**Residential/commercial subdivision, Pt Lot 402
Rae Road, Cockburn Sound Location 16,
Rockingham.**

**Report and recommendations
of the Environmental Protection Authority**

**Environmental Protection Authority
Perth, Western Australia
Bulletin 892
May 1998**

Figure 3. Recommended P&R reserve modification and location of Vegetation Community 19.

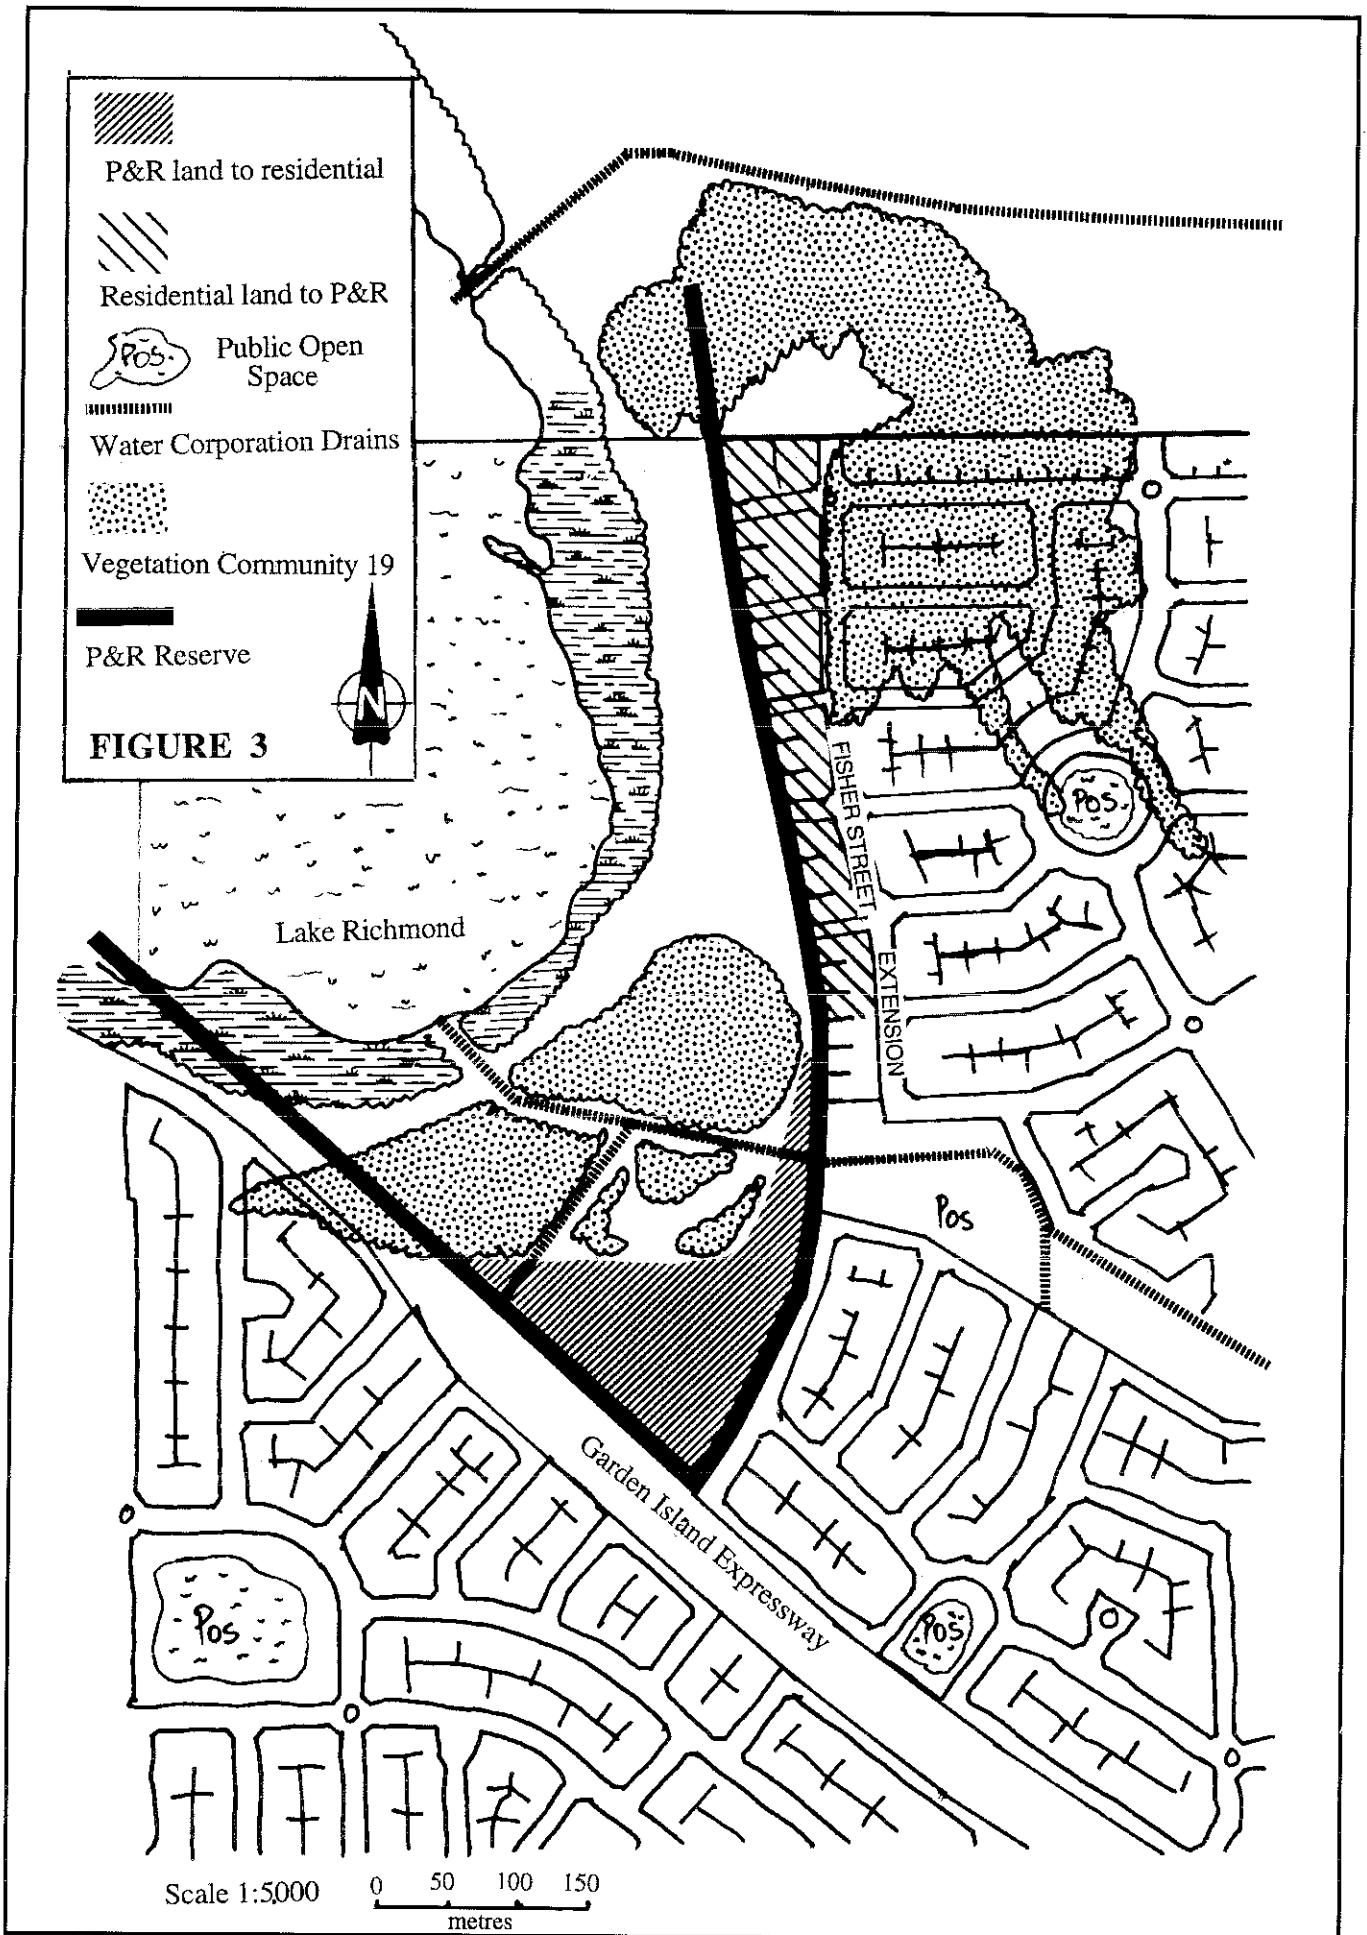
The P&R Reserve contains Lake Richmond and its riparian and dryland vegetation. The setback from the development to Lake Richmond's high water mark is 70 to 370 metres (average 160 metres) (Figure 3). This may not provide an adequate buffer to the Lake and the thrombolites within the Lake.

Based on all the information, the specific circumstances with respect to Lake Richmond and the proposal, the EPA concludes that the buffer should be increased on the eastern margin of Lake Richmond to achieve a minimum 100 metre setback between the development and the riparian (wetland dependent) vegetation. There is the opportunity to achieve this without significantly reducing the area available for development by exchanging current P&R Reserved land, which is cleared, next to the Garden Island Expressway, with land to the west of Fisher Street (Figure 3).

it is the EPA's opinion that the objective can be met subject to the modification of the P&R Reserve in accordance with the notional land exchange occurring, as depicted in Figure 3.

Figure 3. Recommended P&R reserve modification and location of Vegetation Community 19.

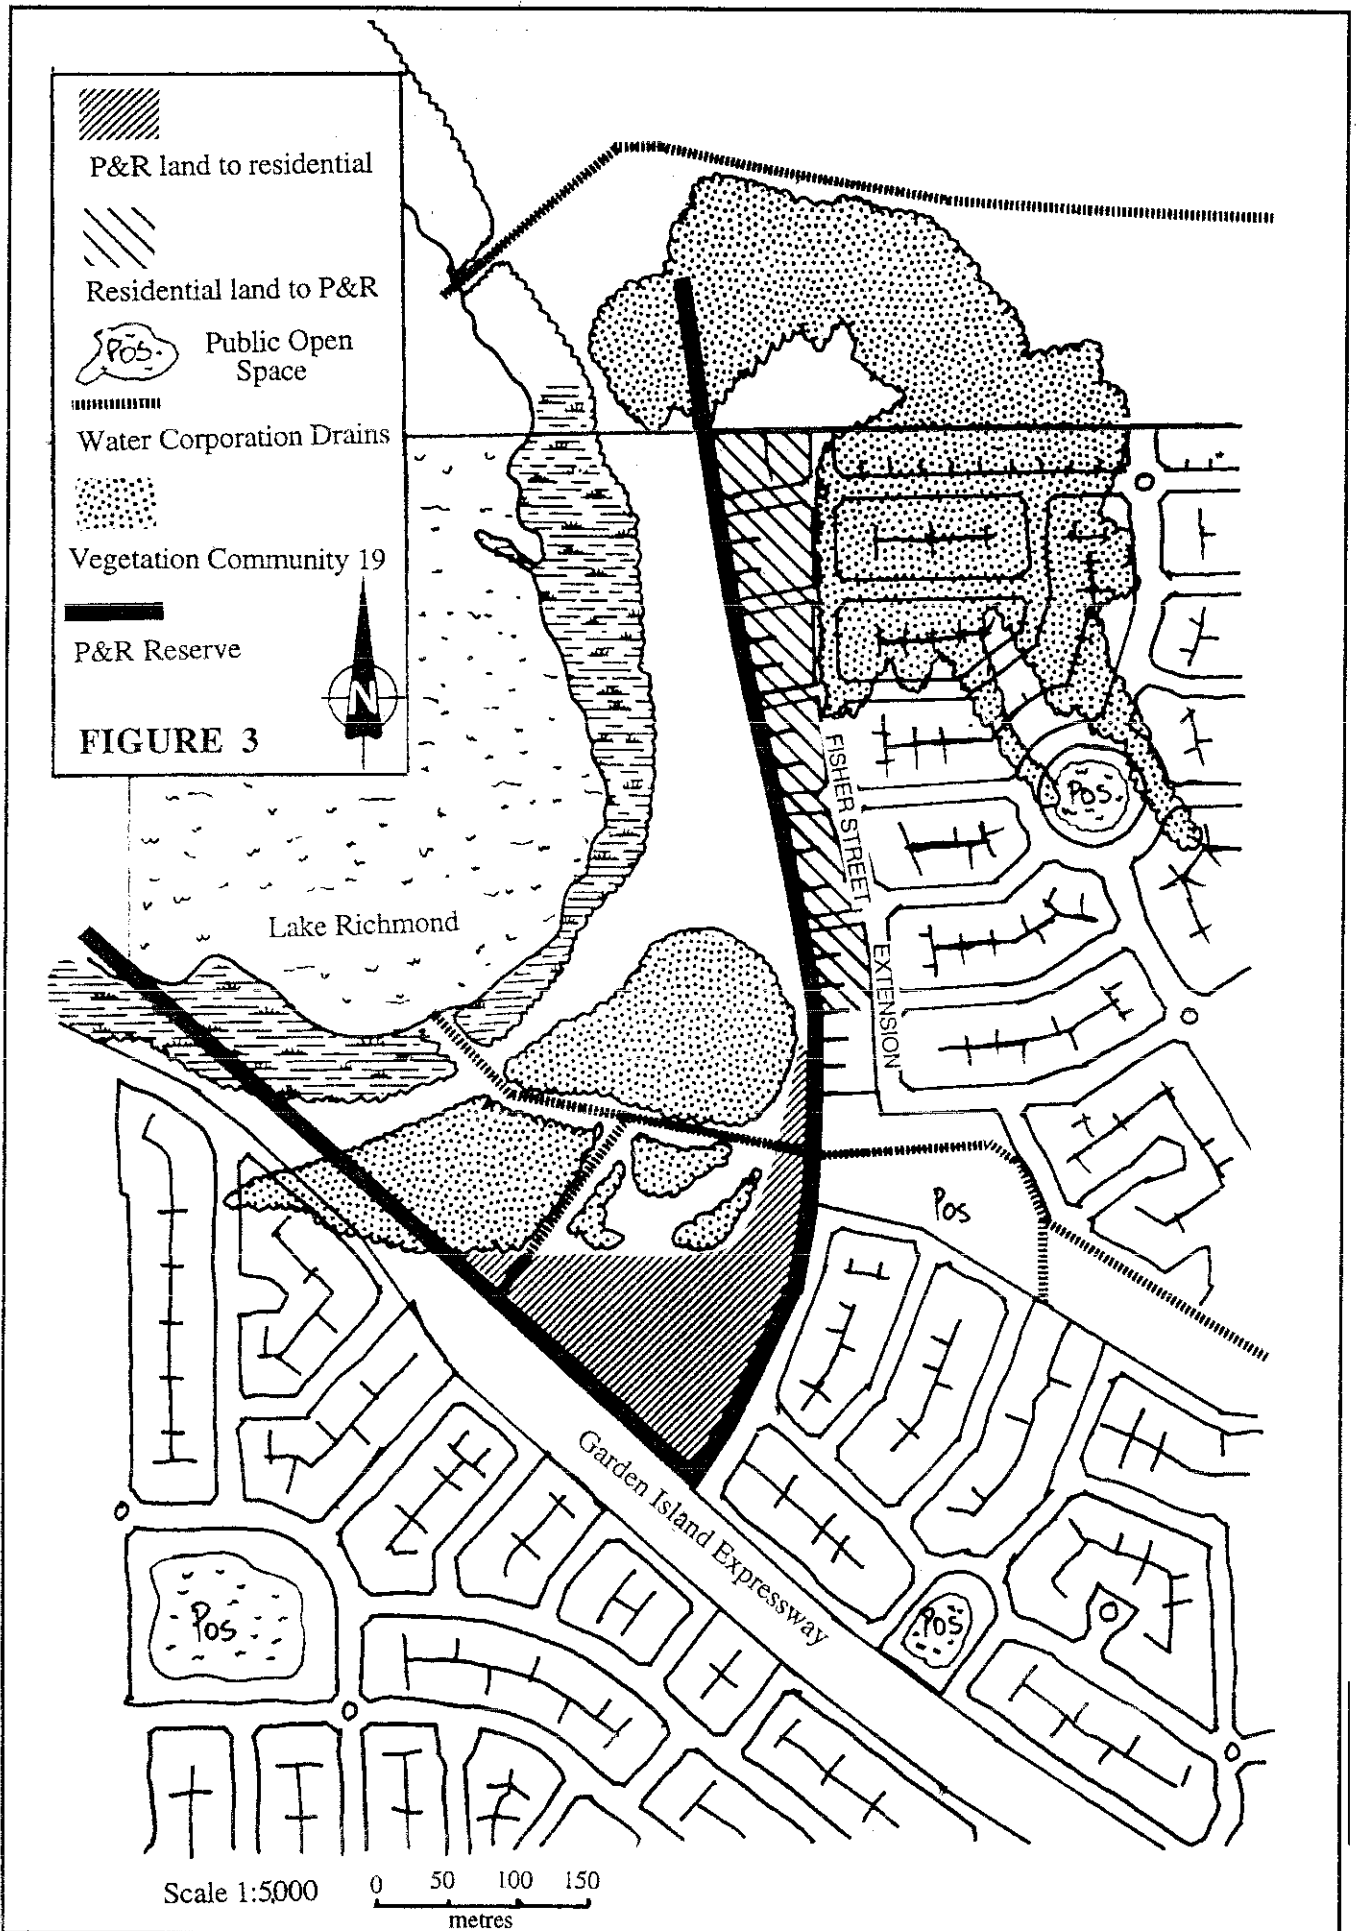
- 1 the boundary of the Parks and Recreation Reserve on the eastern side of Lake Richmond shall be no less than 100 metres from the outermost extent of the wetland dependent vegetation; and
- 2 the Parks and Recreation Reserve may exclude the degraded land in the southern portion of the Parks and Recreation Reserve shown in Figure 1 in Schedule 1 of this statement;

as shown in principle in Figure 3 in Schedule 1 of this statement.
